**East Midlands Gateway
Phase 2 (EMG2)**

Document DCO 7.9/MCO 7.9

EMFM 2019 Sensitivity Test

SEGRO PROPERTIES LTD AND SEGRO (EMG) LTD
East Midlands Gateway 2
VISSIM 2019 EMFM Sensitivity Test Modelling
Technical Note

Figure 3.9: Forecast Flow Change for 2028 'Without Development (1a)' minus 'With Development (2a)'

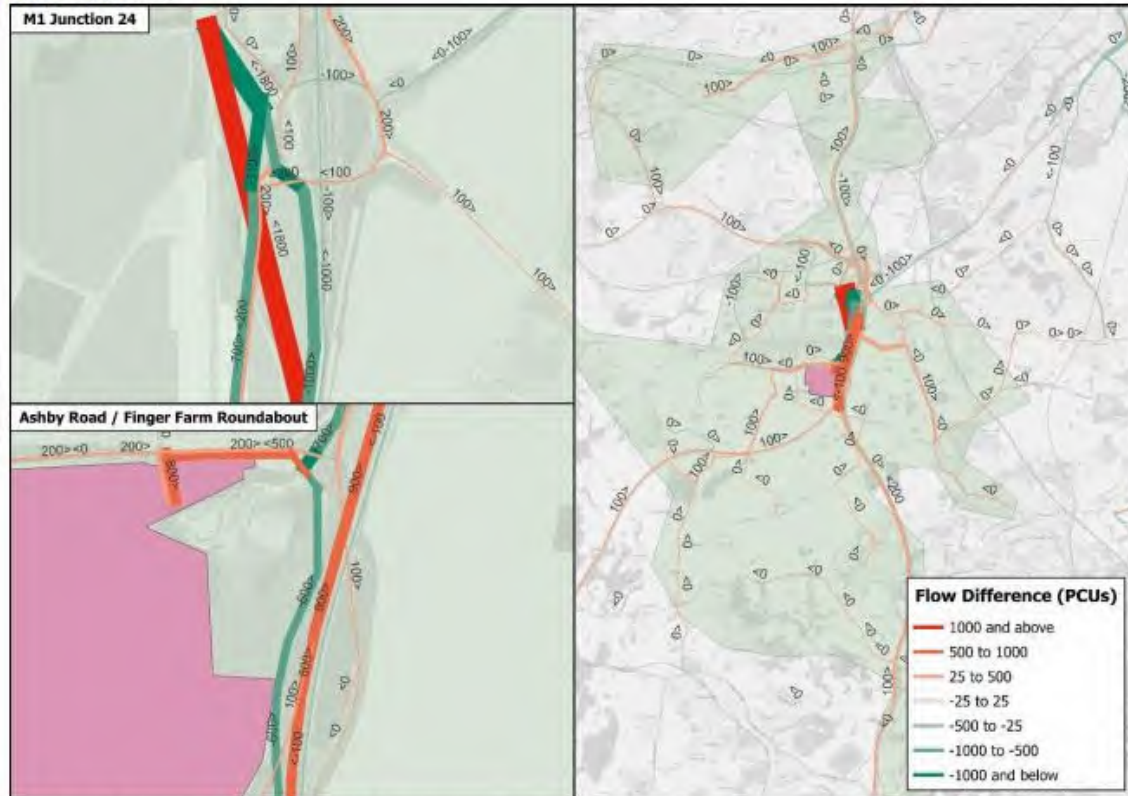
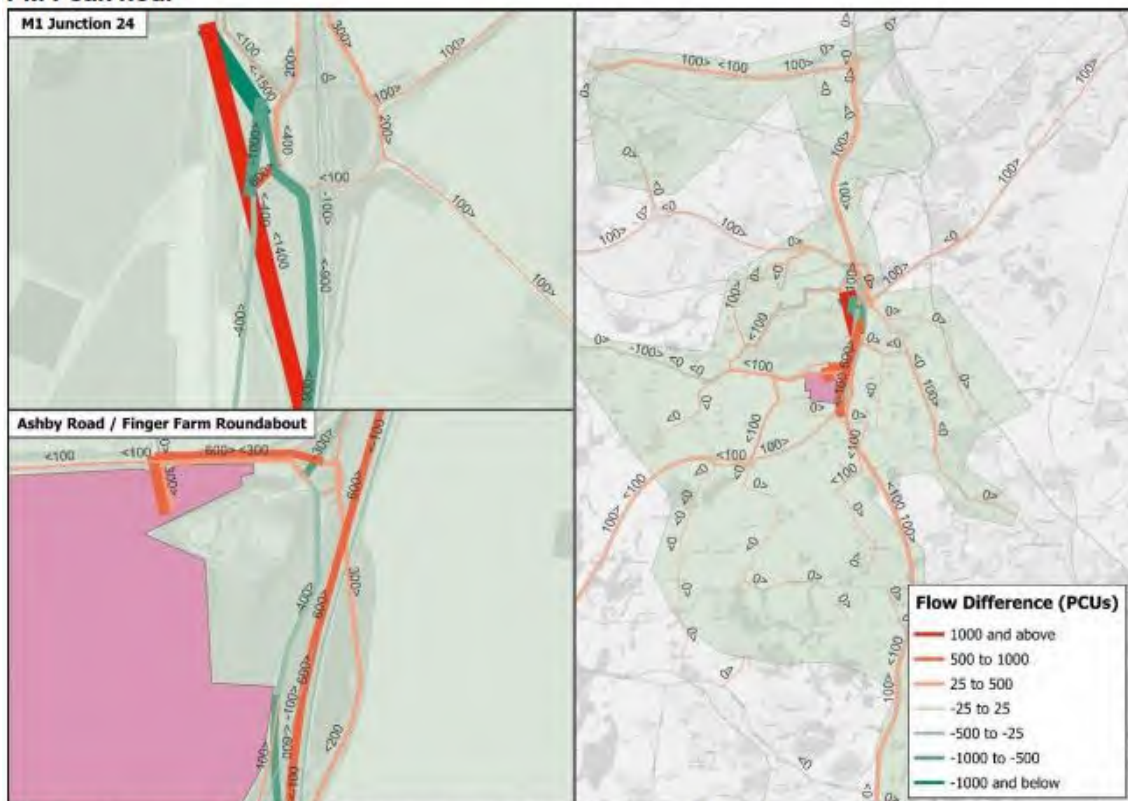
Figures 3.9 - 3.10 show the forecast traffic flow changes associated with the addition of development traffic and mitigation in the 2028 and 2038 AM and PM peak hours.

Figure 3.2: Light Vehicle Trip Distribution to and from the Proposed Development for 2028 (AM)

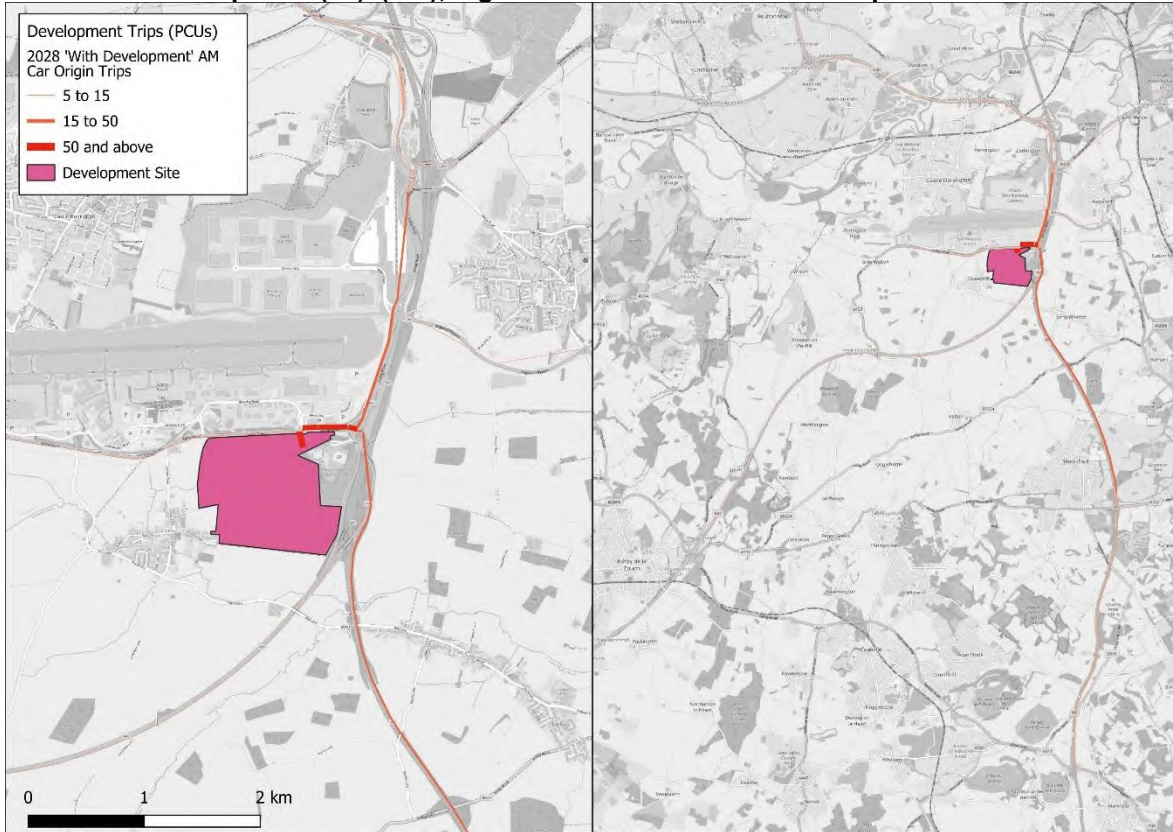
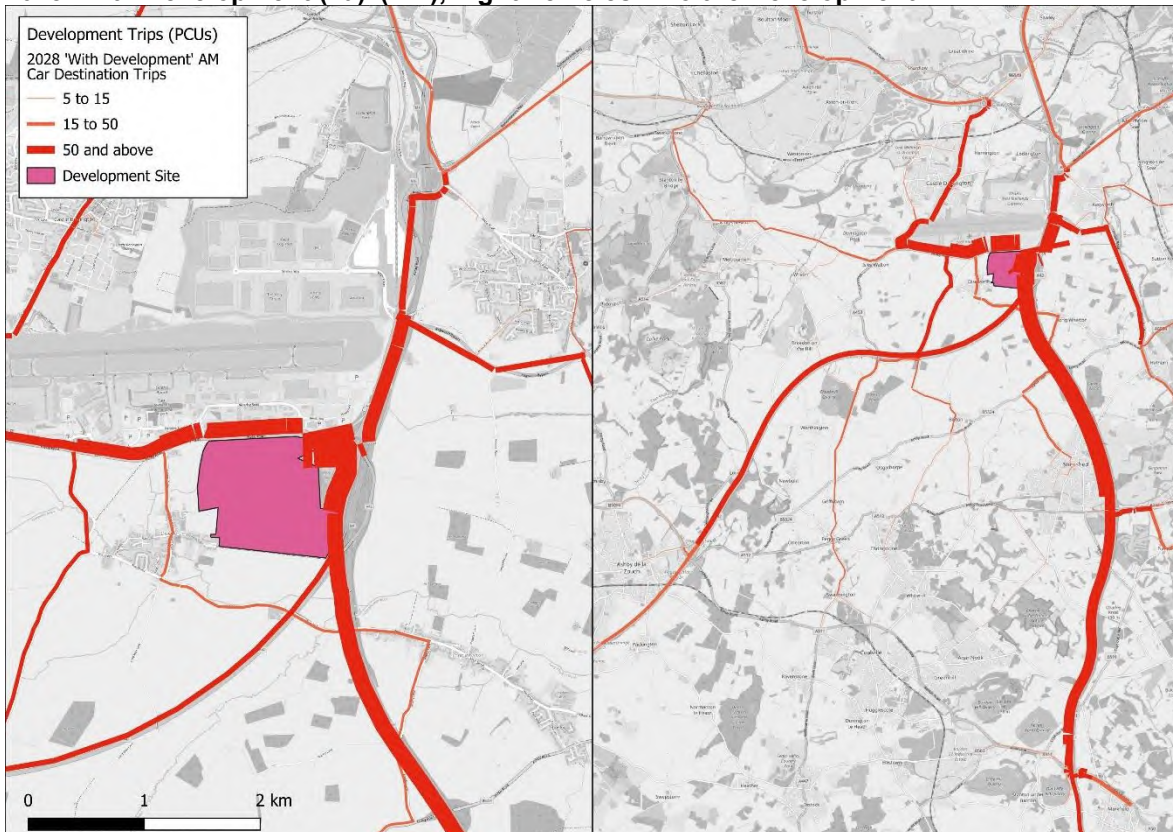
When considering Figure 3.2, there is a potential risk that traffic currently routing through the centre of Castle Donington (appearing to avoid the Relief Road) would more likely route via the M1. The Applicant has quantified the volume of development traffic routing through Castle Donington at 53 light vehicle trips in the AM peak hour in 2028 and 45 light vehicle trips in the PM peak hour. The potential risk of understated demand on the SRN is therefore considered sufficiently low.
